RE: LAND TO THE WEST OF HULBERT ROAD, HAVANT

Please find below additional information in response to your comments at planning to the WYG Flood Risk & Drainage Assessment (FRDA) (ref. A096474, dated April 2020) for the above named site.

Drawing Title:
OVERLAND FLOW ROUTES

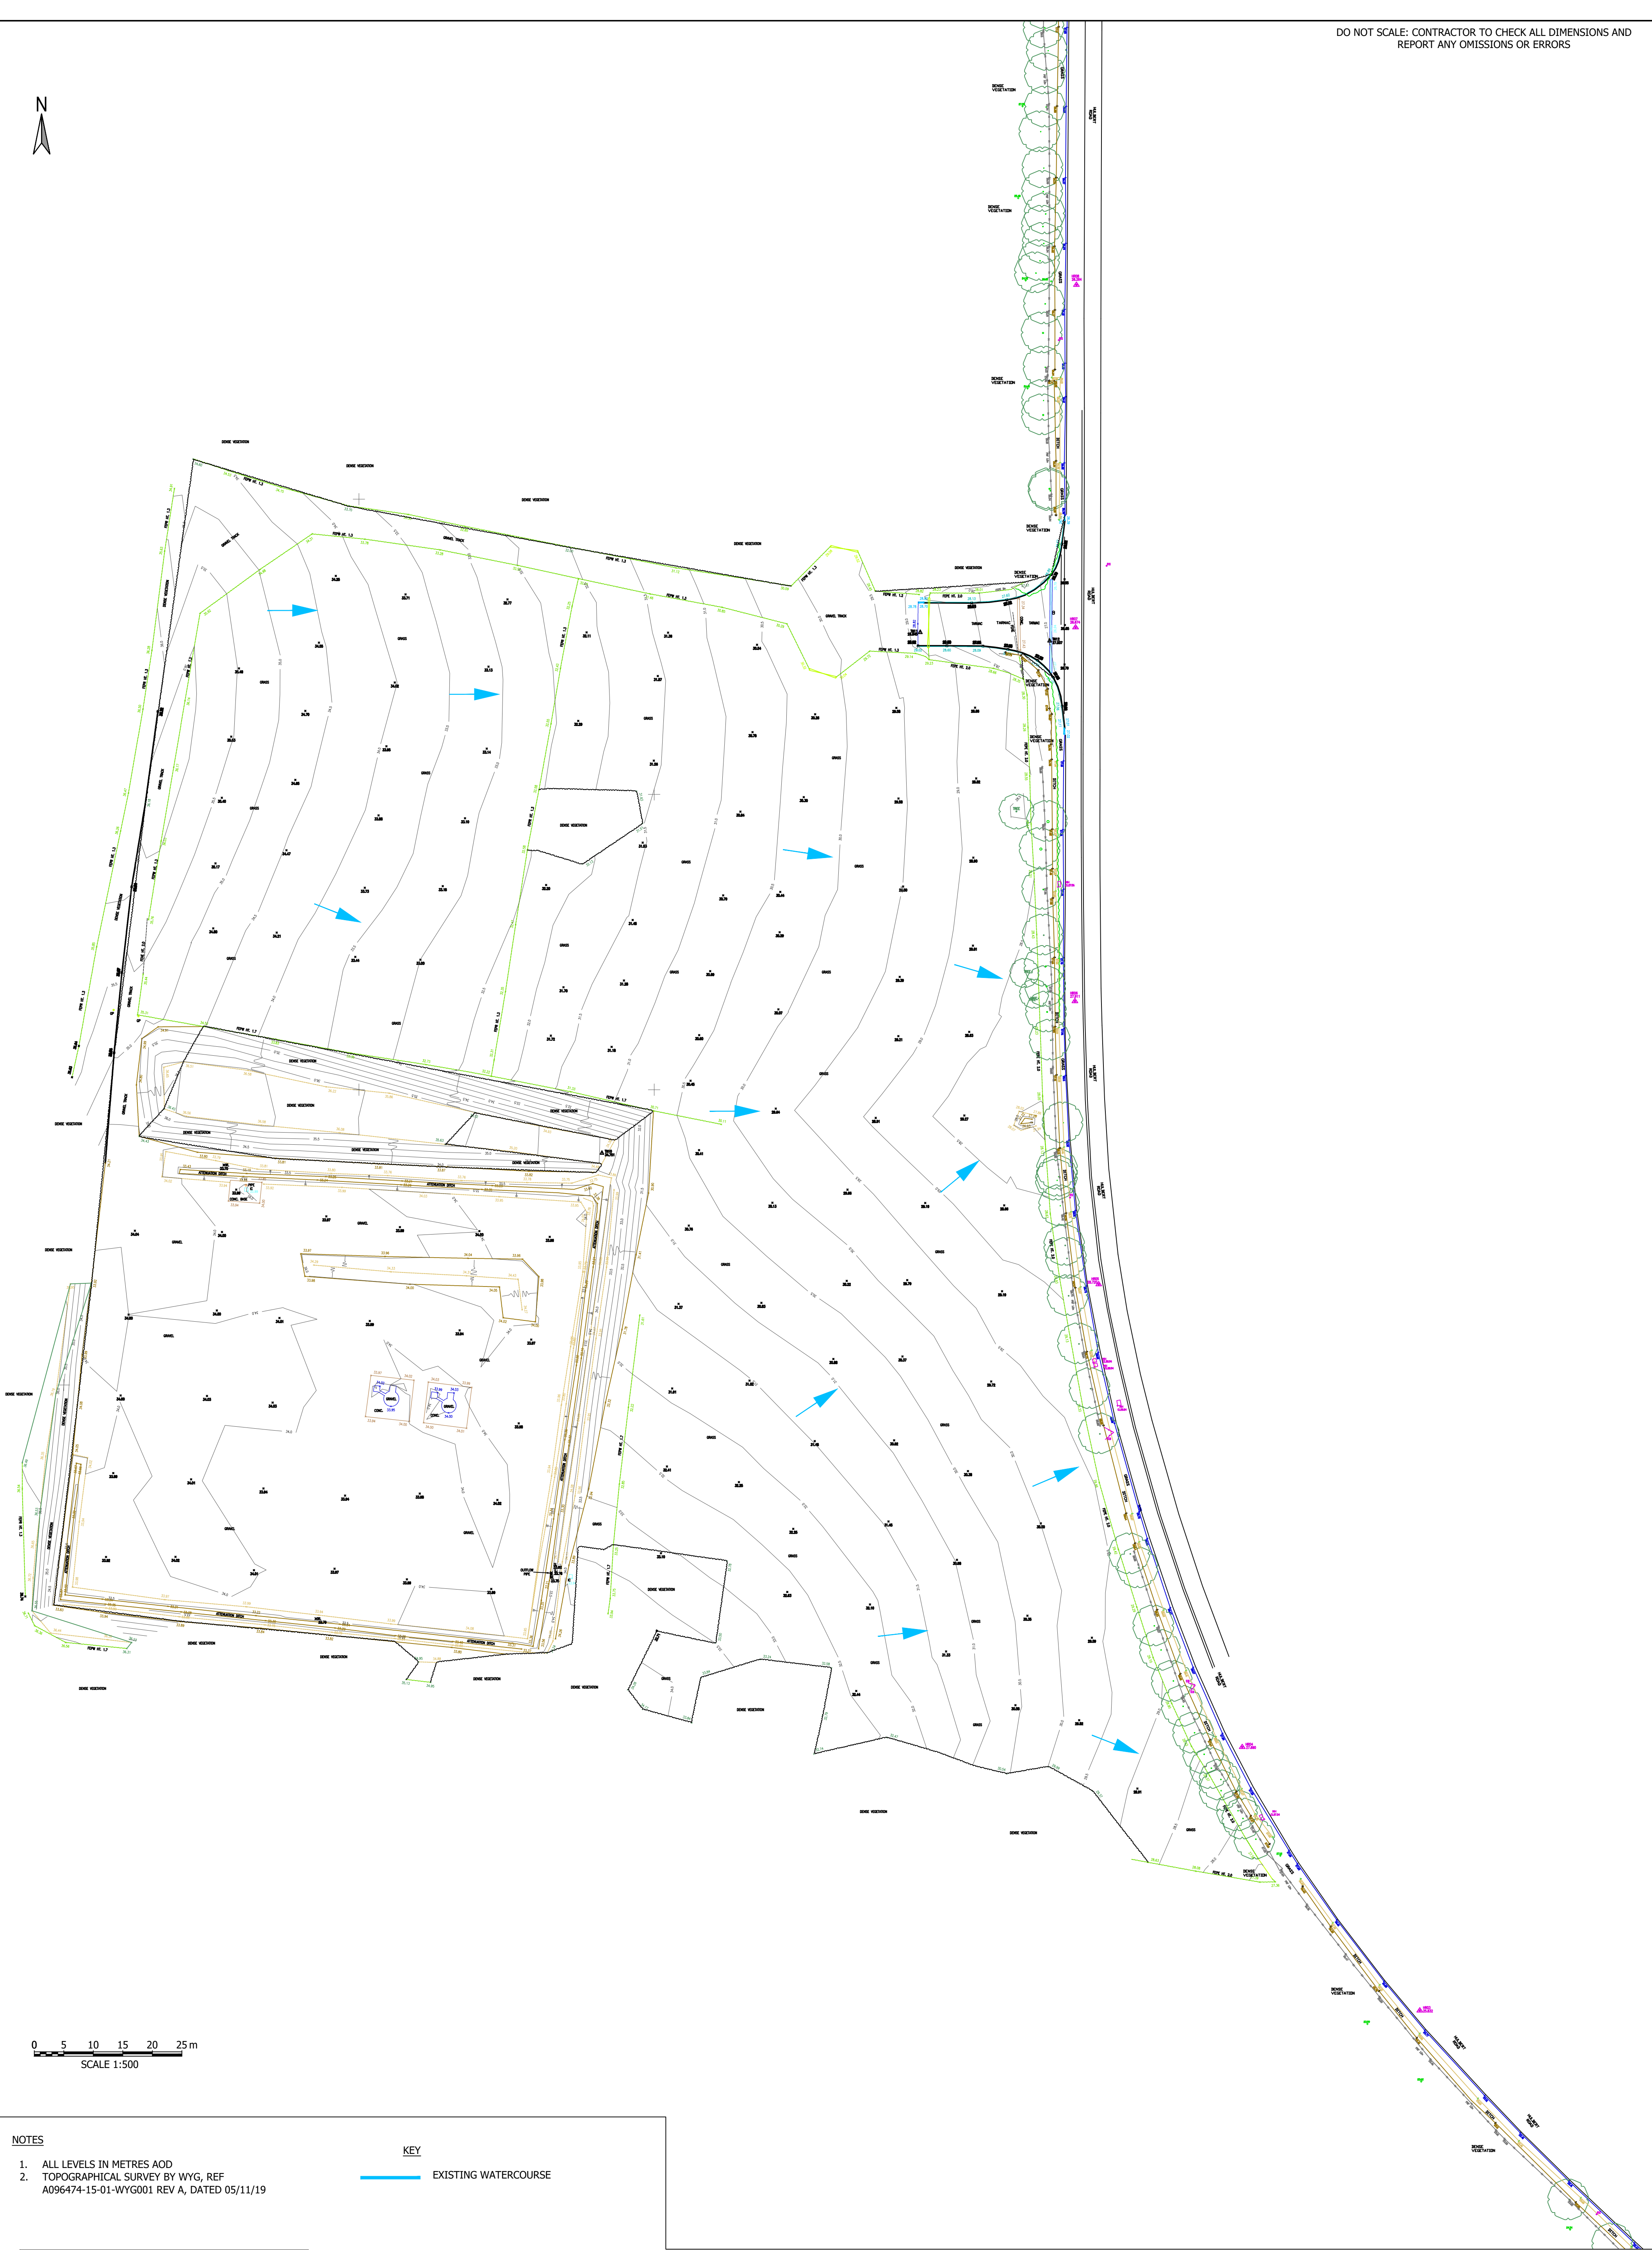
1. Evidence of and information of the existing surface water flow paths of undeveloped (greenfield) sites.

2. Evidence that the proposed drainage will follow the same pattern as the existing.

As described in Section 3.2 of the FRDA, there are no significant flow paths on site, as shown on the Environment Agency's Surface Water Flood Risk Map. In the event of exceedance floods, Section 4.6 of the FRDA describes that the roads and open space levels should be set so that overland flood routes reflect the current scenario in that runoff will drain towards Hulbert Road, following the natural contours of the ground and away from the buildings. Please find enclosed a plan indicating overland flow routes based on the site's topographical survey.

As described in Section 4.5.3 of the FRDA, the proposed drainage rate is restricted to the existing greenfield Qbar rate for all storm events. The outfall is to 'Watercourse B' to the south of the site rather than to the assumed highway ditch on the western side of Hulbert Road as it is preferable to discharge to a formal watercourse with known connectivity (i.e. a tributary of the Hermitage Stream). The

topographical survey does not indicate the connectivity of the highway ditch. It is possible that the highway ditch discharges to Watercourse B either directly or via highway drains.
